POLICE STATION – 10 HAZEN STREET

INTRODUCTION

The following report was prepared for the Town of Norwich Vermont by a team of professionals assembled by Mink Brook Management, LLC with the intent to identify the code and functional deficiencies within the three Town buildings housing the Department of Public Works, the Town Police Department, and the Town Fire Department. We have included in this report budget figures showing estimated costs to bring these buildings up to code and meet the functional standards typical for each department if these buildings were new today. The standards were identified by the team of professionals who have designed and constructed complexes in each of the categories discussed. We understand that each of these buildings is in need of maintenance work at this time and there are line items in the budget showing some of the maintenance repairs identified during our inspections. It is not the intent of this report to try to sway the Town of Norwich to perform the remedial work as described as it may not be in the best interest of the Town to do so. It is the intent of the report to inform the Town of Norwich of the costs associated with the work describ

Photograph No. 7: Flammable ceiling tile typical throughout the building.

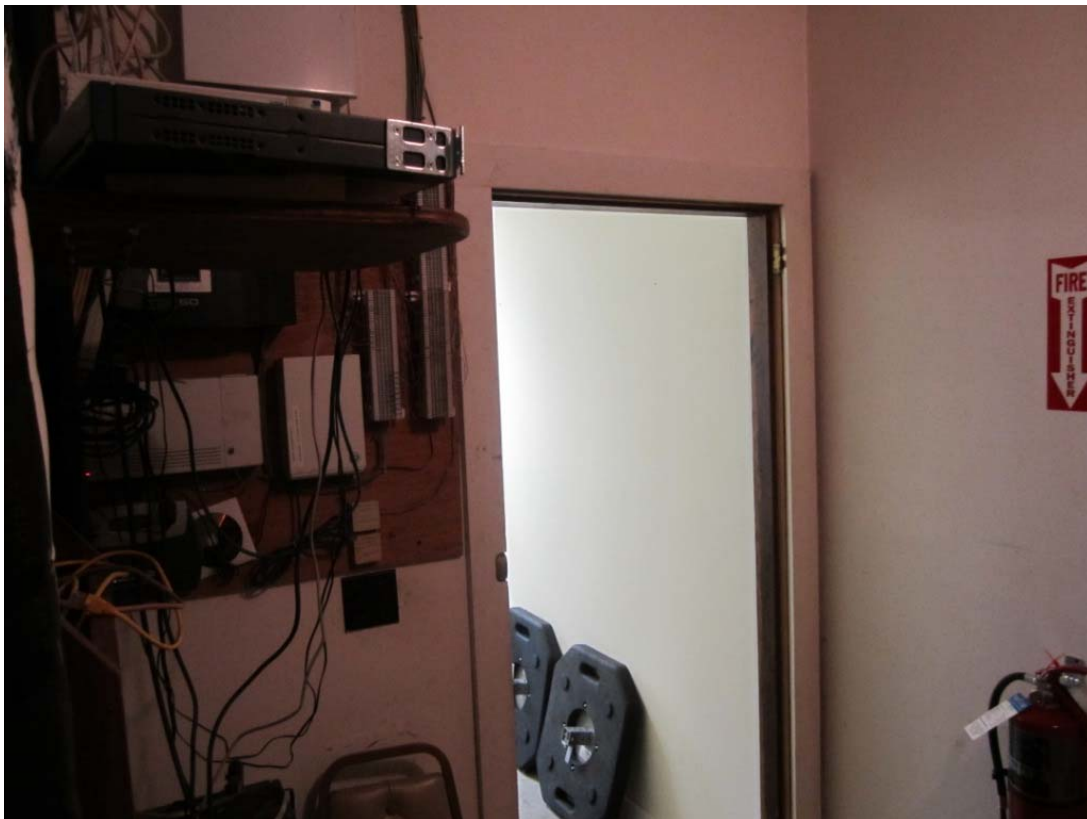
- 3.7. Interior ceiling finish tiles are required to have a flame spread rating not greater than 200 and a smoke developed rating not greater than 450. (IBC 2006, section 803)

- 3.7.1. The existing ceiling tiles do not meet the characteristics discussed in the above code and are within violation for this IBC requirement. The ceiling grid should be torn out and replaced by a ceiling product that does meet the flame and smoke spread rating. For proposes of this report we carried the cost of the demolition of the existing tile, and the installation of a standard 2 x 4 grid of suspended, insulated ceiling tile. Estimated Cost ... \$6,200
